Liffey Valley to City Centre Core
Bus Corridor

Desktop Safety Review

Document Ref:	P18-083-PSW1-RP-001
----------------------	----------------------------

Location: Drawing Sheet 1 - Ballyowen Road

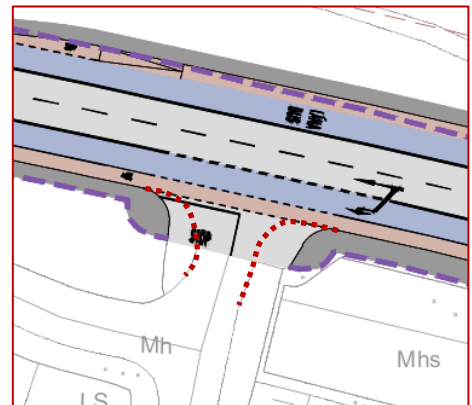
Summary: Proposed location of bus stop may impede visibility for drivers exiting from nearby side road and/or impede visibility for drivers approaching the signalised pedestrian crossing immediately downstream.

A bus stop is proposed on the northern side of the Ballyowen Road, east of Ballyowen Drive. There is a risk that stationary buses at this bus stop could impede visibility to the left for drivers exiting from Ballyowen Drive, resulting in unsafe exiting manoeuvres and side-on collisions.

In addition, stationary buses at this bus stop may impede visibility of eastbound drivers in the adjacent traffic lane towards the signals at the pedestrian crossing immediately downstream, resulting in approaching drivers being unaware of the need to stop, leading to a failure to stop and overshoot into the crossing resulting in possible vehicular/pedestrian collisions.

Relocate the proposed bus stop.

Location: Drawing Sheets 4, 5, 6 & 7 – Roundabout Junctions

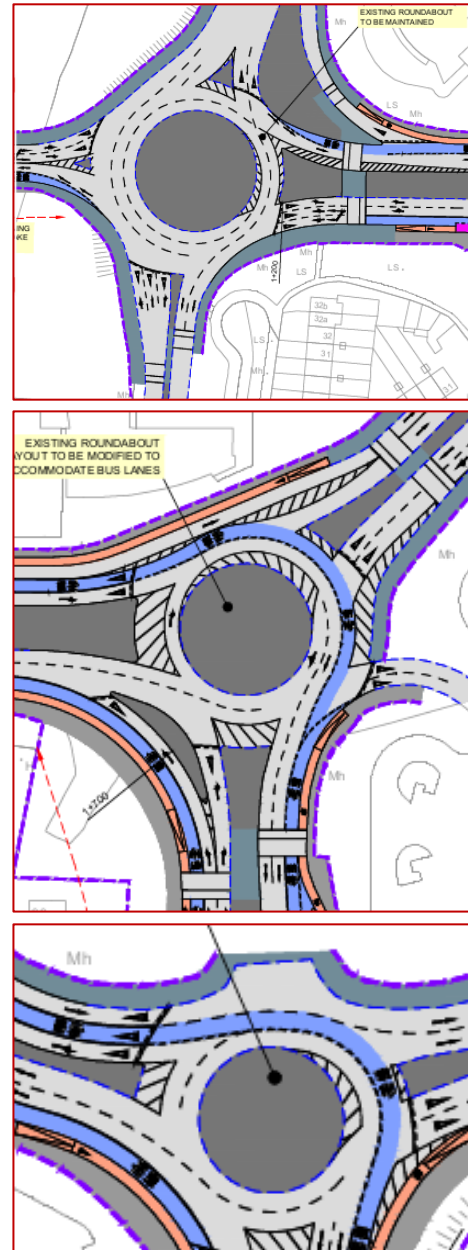
Summary: Proposed retention & modification of existing roundabout junctions will increase junction complexity for all road users leading to an increased likelihood of collisions, in particular between vehicles and vulnerable road users.

The proposed layouts of the series of roundabout junctions along the route between the Fonthill Road and the Coldcut Road will be difficult to navigate for vulnerable road users, in particular cyclists.

In order to progress along the route cyclists will have to undertake lengthy detours in order to access the proposed signalised crossings on the roundabout arms, where these are provided.

Many cyclists may choose to try to navigate the multi-lane roundabout circulating carriageways rather than undertake these lengthy detours placing them at significant risk of being struck by a vehicle.

Where signalised crossings are not proposed on the arms of these roundabouts cyclists will have to enter the circulating carriageway and attempt navigate the roundabout alongside vehicles, and pedestrians must undertake uncontrolled crossings.

The introduction of a third lane, e.g. bus lane, on existing two-lane roundabouts also increases the complexity for drivers with a resulting increased likelihood of inappropriate or unsafe lane-change manoeuvres on the entry or exit of these roundabouts leading to side-swipe collisions with vehicles in the adjacent lane.

Where the addition of the bus lane consists of a right-turn through the junction the resulting complex road layout may not be readily understood by many, indeed most, drivers resulting in driver hesitation and shunt collisions or driver confusion and inappropriate or late manoeuvres leading to side-swipe collisions.

The proposed location of pedestrian or toucan signalised crossings immediately downstream from the roundabout exits could result in drivers, particularly those on dedicated left-turn lanes at the roundabouts, being insufficiently aware of the upcoming crossing as their attention would have been focused on other traffic as they exit the roundabout, leading to a failure to stop, overshoot incidents and possible collisions with crossing pedestrians.

In addition, the retention of these roundabout junctions is inconsistent with the proposed treatment elsewhere along the route, both to the west and east, where existing roundabouts are proposed to be replaced by signalised junctions.

Provide signalised junctions at these locations.

Location: Drawing Sheet 4 - Fonthill Road

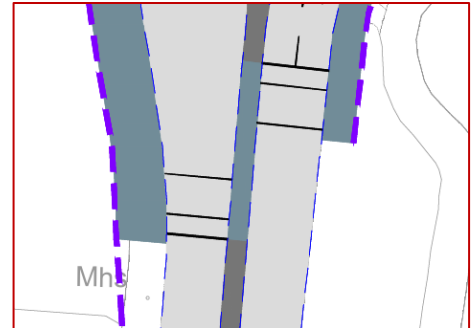
Summary: Unclear if refuge island within the signalised crossing is of adequate width to cater for the likely volumes of pedestrians/cyclists at this location.

A signalised crossing, presumably a toucan crossing, has been indicated on the Fonthill Road south of its junction with the Ballyowen Road.

It is unclear if the refuge island within this crossing is of adequate width to cater for the likely volumes of pedestrians and to/or cyclists likely to use this crossing, in particular when items of roadside furniture had been placed within the island.

Insufficient width of refuge can increase the likelihood of pedestrians or cyclists within the refuge being struck by part of a passing vehicle.

Ensure that adequate width is provided within refuges proposed as part of the project.

Location: Drawing Sheet 5

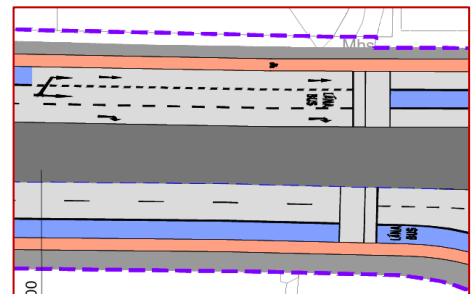
Summary: Continuous cycle track indicated at signalised pedestrian crossing.

The cycletracks on the road to the west of the roundabout are indicated as being continuous through the signalised pedestrian crossing, which could result in collisions between cyclists and pedestrians waiting to cross at this location.

Either provide a discontinuity in the cycletrack at this location, with cyclists required to stop on a red signal, or create a shared surface to facilitate cyclists and pedestrians mixing along this section of road.

Location: Drawing Sheet 5

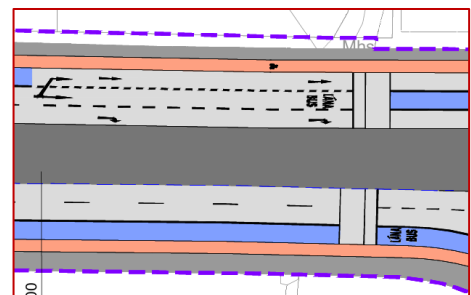
Summary: Proposed weaving length on the immediate approach to signalised crossing could result in overshoot incidents and vehicular/pedestrian collisions.

A weaving length has been indicated on the eastbound approach to the signalised pedestrian crossing, where buses must move right in order to turn right at the roundabout further downstream, and where traffic wishing to proceed straight-ahead at the roundabout must move left.

The length of this weaving section is relatively short, and it is located on the immediate approach to a pedestrian crossing.

Drivers undertaking weaving manoeuvres may be insufficiently aware of the status of the signals at the pedestrian crossing, resulting in a failure to stop leading to overshoot incidents and collisions with crossing pedestrians.

In addition, many drivers may not be aware of the need to move left in order to proceed straight-ahead at the upcoming roundabout junction, resulting in late lane-change manoeuvres on the immediate approach to the signalised pedestrian crossing and possible side-swipe collisions.

Relocate the weaving length to a point further upstream of the signalised crossing so that all lane change manoeuvres are completed well in advance of the crossing. During the design development ensure that adequate signage & roadmarkings are provided to clearly advise drivers of the lane to adopt in order to achieve their intended destination.

Location: Drawing Sheet 5

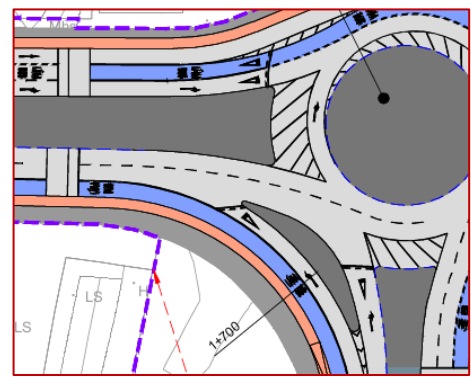
Summary: Signalised pedestrian crossing indicated immediately downstream of dedicated left-turning lane resulting in possible overshoot by left-turning vehicles into the crossing.

A signalised pedestrian crossing has been indicated immediately downstream of a dedicated left-turn lane at the roundabout.

Drivers exiting from the left-turning lane will have their focus primarily to the right, towards other vehicles exiting from the nearby roundabout, and may be insufficiently aware of the status of the signals at the pedestrian crossing resulting in a failure to stop and overshoot into the crossing, leading to vehicular/pedestrian collisions.

Either relocate the signalised pedestrian crossing so that there is a greater distance between the left-turning lane and the crossing to allow drivers sufficient distance/time to be sufficiently aware of the crossing, or replace the proposed roundabout junction with a signalised junction with the pedestrian crossings incorporated into it.

Location: Drawing Sheet 5

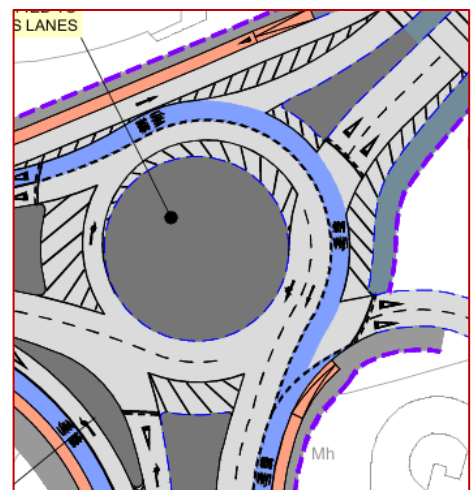
Summary: Hatched roadmarkings at roundabout junction will fade over time rendering the layout indistinct leading to unsafe manoeuvres and collisions.

A significant amount of hatched roadmarkings are proposed at the roundabout junction to guide drivers.

These hatched markings will fade/wear-off over time, and the layout may become indistinct and insufficiently clear, resulting in unsafe manoeuvres and side-swipe collisions.

Amend the proposed junction layout to replace at roadmarkings with kerbed build-outs/islands.

Location: Drawing Sheet 5

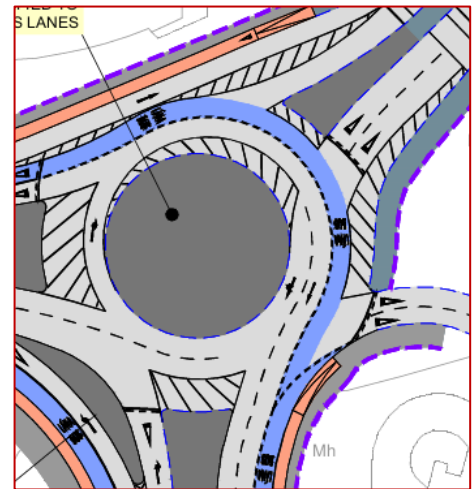
Summary: Complex roundabout junction layout may lead to delays resulting in rash/unsafe manoeuvres and collisions.

The proposed roundabout layout is complex and some of the entry arms may encounter significant delays (e.g. exit from car park), leading to lengthy queues forming.

These queues may, in turn, lead to driver frustration and rash/unsafe manoeuvres resulting in collisions.

Signalise this junction.

Location: Drawing Sheet

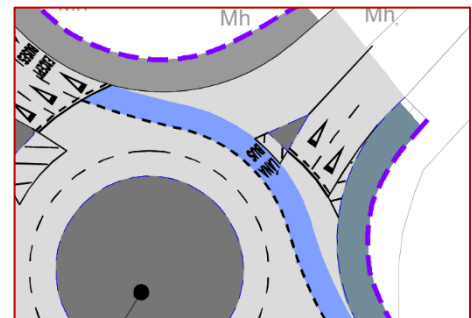
Summary: Resulting size of splitter island likely to be insufficient to act as a pedestrian refuge while accommodating the required signage.

In order to include the proposed bus lane within the existing roundabout the splitter islands on the arms to the north-east and south-west have been curtailed.

The resulting size of these splitter islands are unlikely to be sufficient to act as a pedestrian refuge while accommodating necessary signage.

Insufficient size of refuge can increase the likelihood of pedestrians or cyclists within the refuge being struck by part of a passing vehicle.

During the design development ensure that the splitter islands at all of the roundabout junctions are capable of functioning as a pedestrian refuge while accommodating all of the required signage.

Location: Drawing Sheets 5 & 6

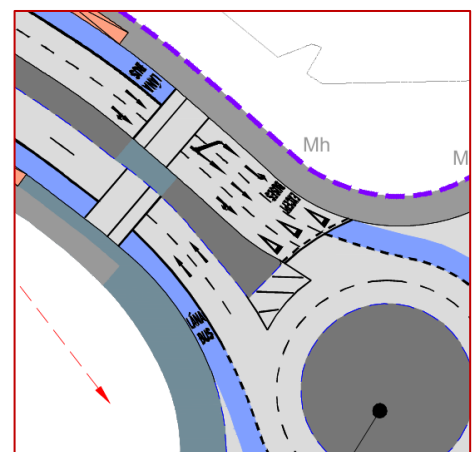
Summary: Queues forming at signalised crossings located immediately downstream of roundabout exits may extend upstream into the roundabout circulating carriageway creating congestion, leading to driver frustration and resulting in rash manoeuvres.

Signalised pedestrian crossings have been indicated immediately downstream of a number of roundabouts within the Liffey Valley area.

The proximity of these signalised crossings to the roundabouts could result in queues at the signalised crossings extending back into the upstream circulating carriageway, leading to congestion and obstructions to drivers attempting to enter the roundabout from the other arms. This could lead to driver frustration and rash/unsafe manoeuvres.

If the signalised pedestrian crossings were located to points further downstream of the roundabout exits, this could address this issue, but the crossings may then no longer be on the likely pedestrian desire line resulting in unsafe pedestrian crossing.

Therefore, it is recommended that the roundabouts be replaced by signalised junctions with pedestrian crossings incorporated within them.

Location: Drawing Sheet 8

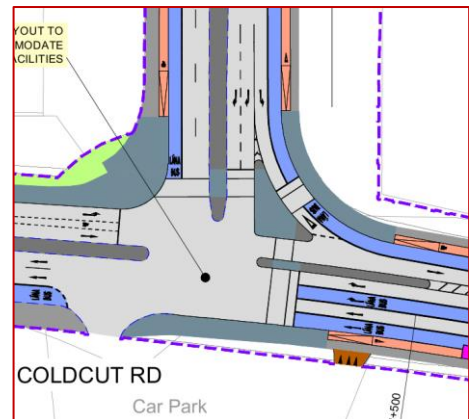
Summary: Absence of facilities to cater for right-turning cyclists at signalised junction increases the risk of vehicular/cyclist collisions.

No measures are proposed to facilitate cyclists wishing to turn right at the Liffey Valley/Coldcut Road junction.

This will result in cyclists having to mingle with vehicular traffic, and in some cases weave across multiple traffic lanes, in order to turn right placing them at an increased risk of being struck by a vehicle.

Amend the proposed junction layout to include measures to facilitate right-turning cyclists.

Location: Drawing Sheet 8 – Coldcut Road

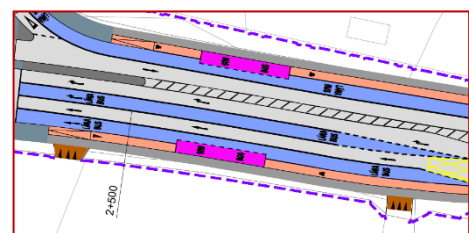
Summary: Development of numerous lanes over short distance may lead to late lane-change manoeuvres and side-swipe collisions.

The proposed road layout on Coldcut Road is relatively complex, and includes the development of a number of lanes over short distance west of the M50 Overbridge on the approach to the signalised junction with Liffey Valley.

The number of different lanes developed over this short section is likely to lead to driver confusion and late lane-change manoeuvres resulting in possible side-swipe collisions.

Rationalise the number of lanes being developed over this short section of road to minimise driver confusion and promote compliance with the road layout.

Location: Drawing Sheet 8 – Coldcut Road/Liffey Valley Junction

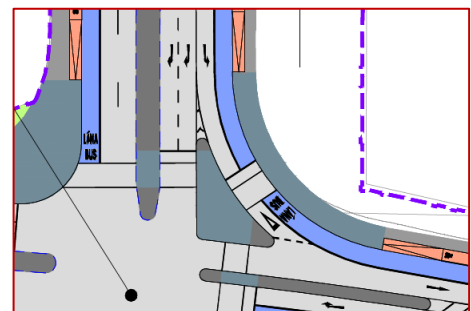
Summary: Unclear if adequate lane width provided where two lanes turn left to accommodate the swept path of large vehicles.

Two lanes are indicated turning left from Liffey Valley onto the Coldcut Road eastbound. It is unclear if any lane widening has been provided within these two left turning lanes.

Should no lane widening be provided there is a risk that the lanes will be insufficient to accommodate the swept path of large vehicles/buses, resulting in encroachment into the adjacent lane and possible side-swipe collisions with vehicles in the adjacent lane.

During the design development undertake a swept-path analysis of the turning movements at this junction and ensure that adequate lane widths are provided to accommodate the swept path of large vehicles/buses turning left.

Location: Drawing Sheet 8 – Coldcut Road

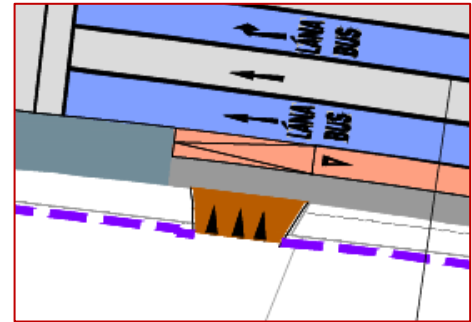
Summary: Right-turning manoeuvres requiring multiple lanes to be traversed likely to result in collisions.

Two private accesses have been indicated on the southern side of the Coldcut Road where a relatively complex road layout is proposed. Vehicles attempting to turn right into, or right out of, these accesses will have to cross a cycle lane, two bus lanes & two traffic lanes.

These manoeuvres would be difficult to complete due to the number of different traffic streams a right-turning driver would have to be aware of, and take account of, in order to complete this manoeuvre safely.

It is considered likely that right-turns into, or out of, these accesses would result in side-on collisions.

Replace the proposed hatching between opposing traffic directions on this section of Coldcut Road with a solid island, and limit access/egress to/from these private accesses to left-in or left-out only.

Location: Drawing Sheet 8 – Coldcut Road

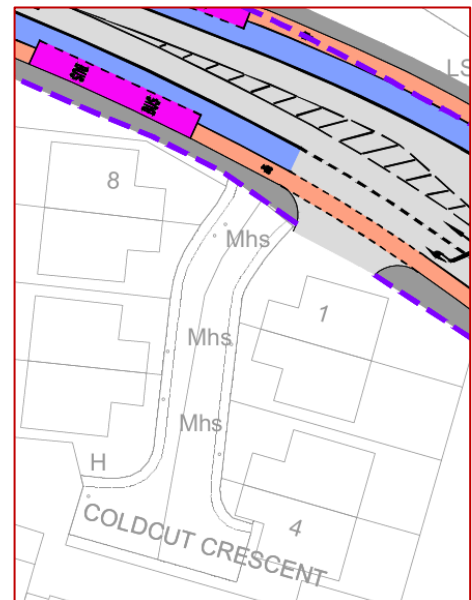
Summary: Private access indicated at same location as transition from on-road cycle lane to off-road shared-use path.

A private access has been indicated at the same location where a proposed cycle facility transitions from an on-road cycle lane to an off-road shared-use facility, immediately east of the Liffey Valley/Coldcut Road junction. This will result in vehicles entering/exiting from this private access traversing a section of carriageway with varying height kerbs.

Either relocate the proposed access or relocate the cycle lane transition.

Location: Drawing Sheet 14

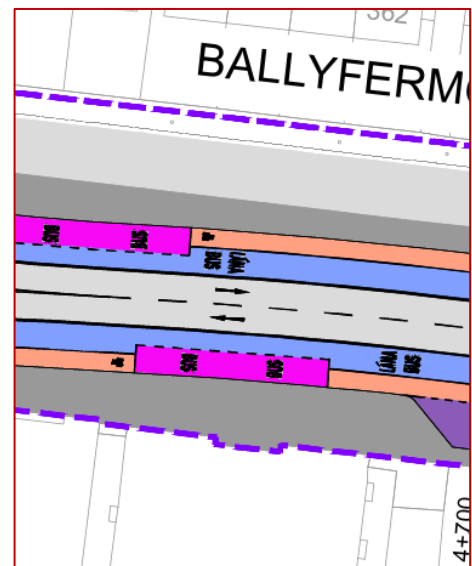
Summary: Absence of controlled pedestrian crossing at location where likely pedestrian desire line will exist across Ballyfermot Road could lead to uncontrolled crossings and vehicular/pedestrian collisions.

No pedestrian crossing has been indicated in the vicinity of the proposed bus stops on Ballyfermot Road near the old Gala Cinema. There is an existing signalised pedestrian crossing at this location at present.

There is a likely pedestrian desire line across Ballyfermot Road at this location to/from the proposed bus stops on either side of Ballyfermot Road and to/from the retail/shopping on the southern side of the road and the residential areas on the northern side of the road.

Provide signalised pedestrian crossing at this location.

Location: Drawing Sheet 14 - Ballyfermot Road/Le Fanu Road Junction

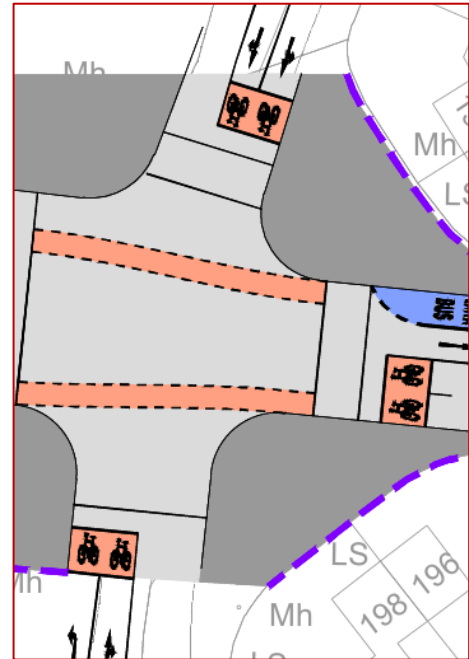
Two straight-ahead lanes have been indicated on Le Fanu Road southbound approach to its junction with Ballyfermot Road, however only a single traffic lane is provided on the Le Fanu Road southbound exit from the junction.

This could result in side-swipe collisions as two traffic lanes attempting to merge into a single traffic lane on the exit from the junction.

Amend the proposed road layout to provide a single southbound straight-ahead lane on Le Fanu Road entering its junction with Ballyfermot Road.

Location: Drawing Sheet 21

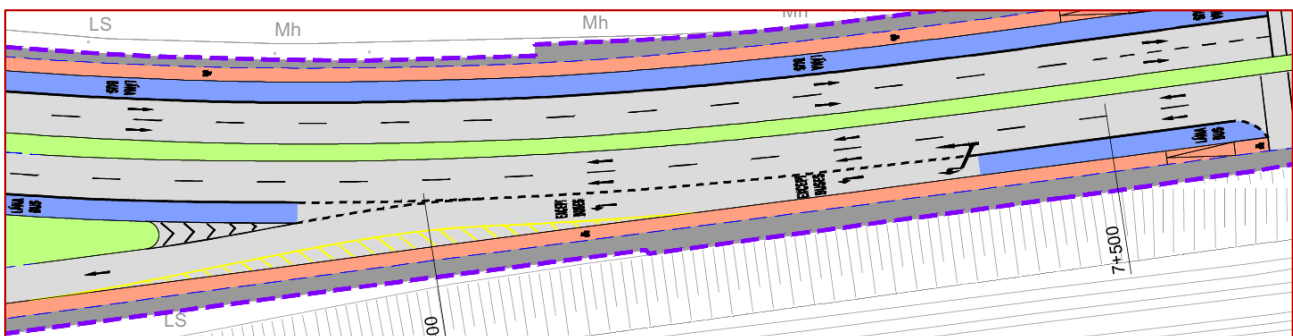
Summary: Increased injury severity outcomes likely should collisions occur between vehicles and cyclists due to higher speeds by left-turning/diverging westbound vehicles at junction of Con Colbert Road & Chapelizod Bypass.

The proposed arrangement for westbound diverging traffic at the Con Colbert Road junction with the Chapelizod Bypass could give rise to high speeds for exiting traffic. The provision of the proposed hatched roadmarkings adjacent to the cycle lane are unlikely to be observed by all drivers, placing cyclists in close proximity to high-speed vehicles with a resulting increased risk of serious injuries should a collision occur.

Retain the existing layout at this location.

Location: Drawing Sheet 21

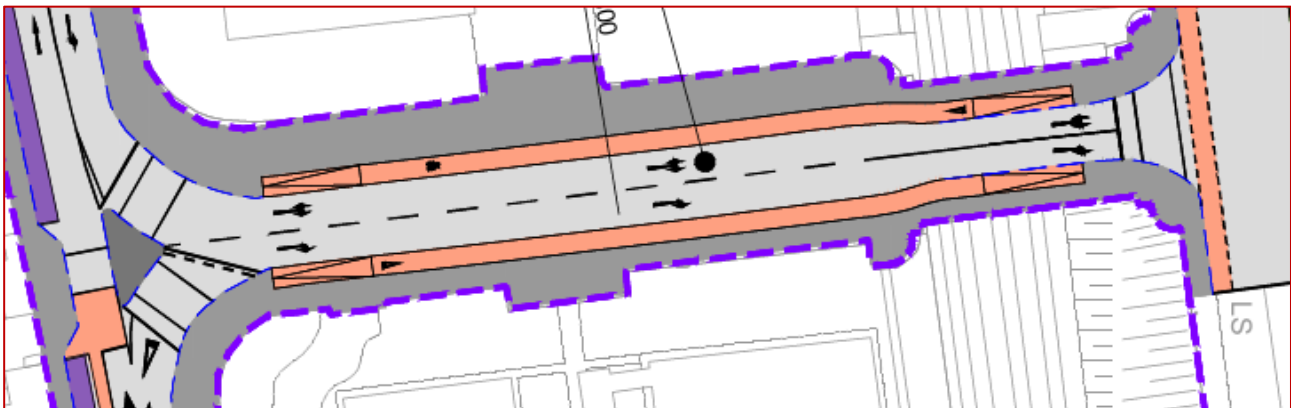
A failure to provide an adequate and safe means for cyclists to travel between the two cycle facilities on Inchicore Road will result in cyclists having to weave across vehicular traffic with an increased risk of being struck.

Amend the proposed road layout to provide a safe route for westbound cyclists on Inchicore Road approaching, and at, the Memorial Road junction.

Location: Drawing Sheet 30 - Bridge Street/High Street Junction and High Street/Nicolas Street Junction

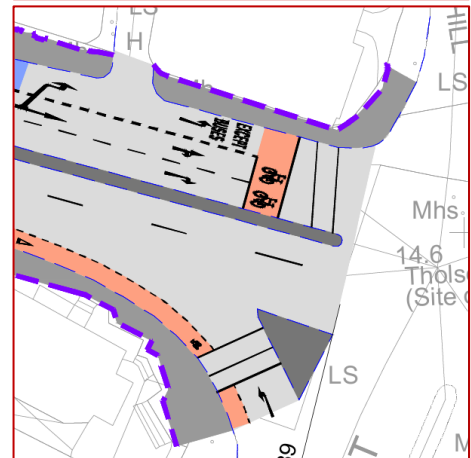
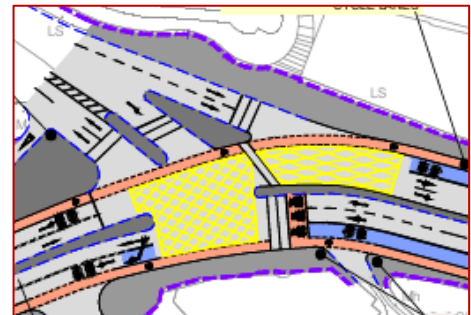
Summary: Absence of measures for right-turning cyclists will result in cyclists mingling with traffic and crossing multiple traffic lanes in order to turn right, with a resulting increased risk of being struck by a vehicle.

No measures have been indicated to facilitate right-turns by westbound cyclists on High Street at the Bridge Street junction or for eastbound cyclists wishing to turn right from High Street onto Nicolas Street.

Amend the proposed junction layout to provide measures catering for right-turning cyclists at this junction.

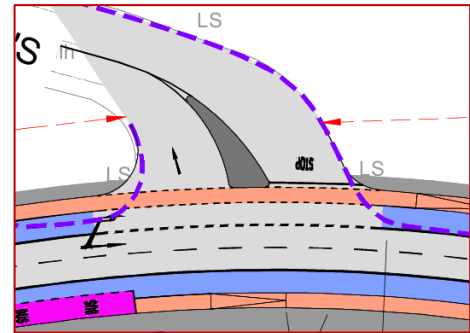
- 5.1 The proposed road layout on St Laurence's Road at its junction with Ballyfermot Road appears to be incorrect, as it does not tie in with the existing carriageway edges and does not show the existing footpaths which it is assumed are to be retained.

It has been assumed that this is a draughting error which will be corrected during subsequent design phases.

Should this assumption be incorrect the Audit Team should be advised, and the audit report amended.
